SRF No. 0148483
 County Project No. 091101

**CSAH 112 – Phase 1
 Project Advisory Committee (PAC) Meeting
 June 17, 2015; 8:00 am – 10:30 am
 Orono City Hall
 MEETING RECORD**

Subject: CSAH 112 Phase 1 Final Design (Willow Drive to Wolf Pointe Trail)
Hennepin County Project No. 091101

6/3/15
Center median at potential
trail crossing with 15.5'
offset west & east of
median. Hold RSS to 60%
Design location.

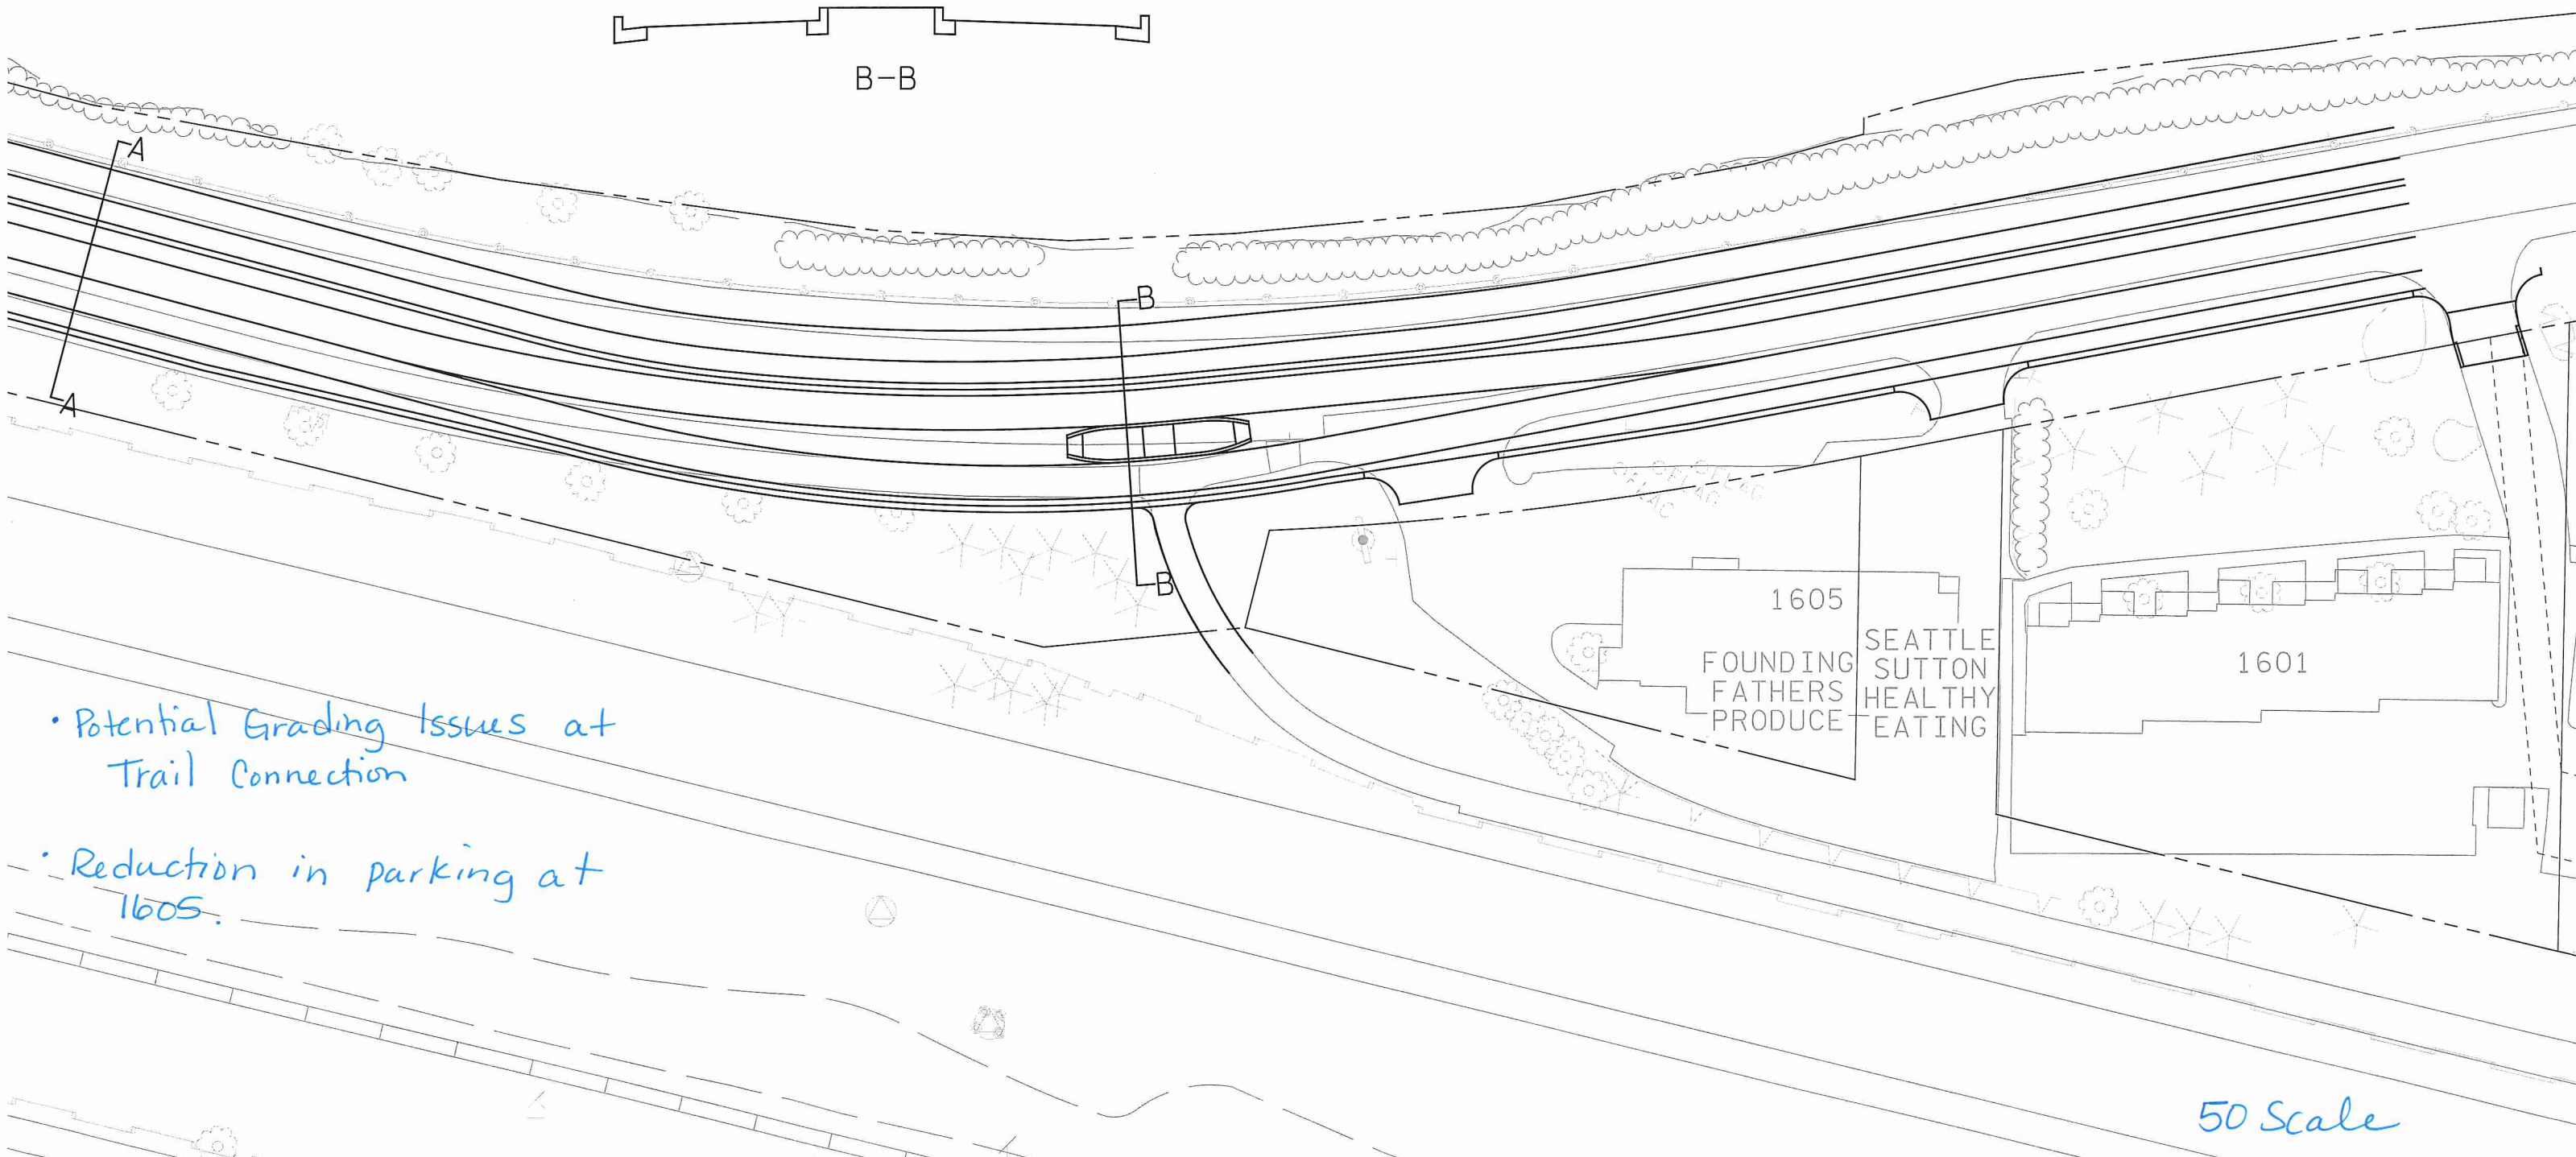
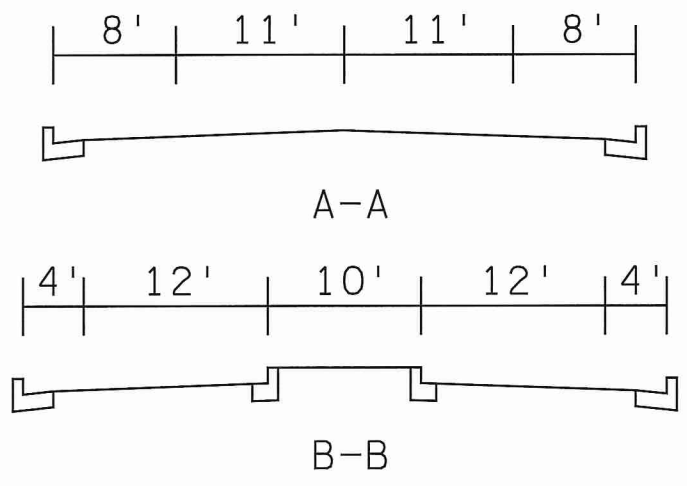
Nate presented another graphic that shows the area near CSAH 112 at the connection of the Long Lake City Trail. He indicated this graphic represents a plan view showing a potential center median at the propose trail crossing. The intent, if the trail moves to the north side, would be to relocate the planned median from near Martha Lane to this location since there would no longer be an official trail crossing needed at Martha Lane. Nate mentioned that the centerline of CSAH 112 is shifted approximately 15.5 feet south, of the original centerline, in order to hold the construction limits in Long Lake. He pointed out on the graphic that shifting the road south brings the roadway closer to the existing properties (1605 & 1606 Wayzata Blvd) along the south side.

- Potential Grading Issues at Trail Connection
- Reduction in parking at 1605.
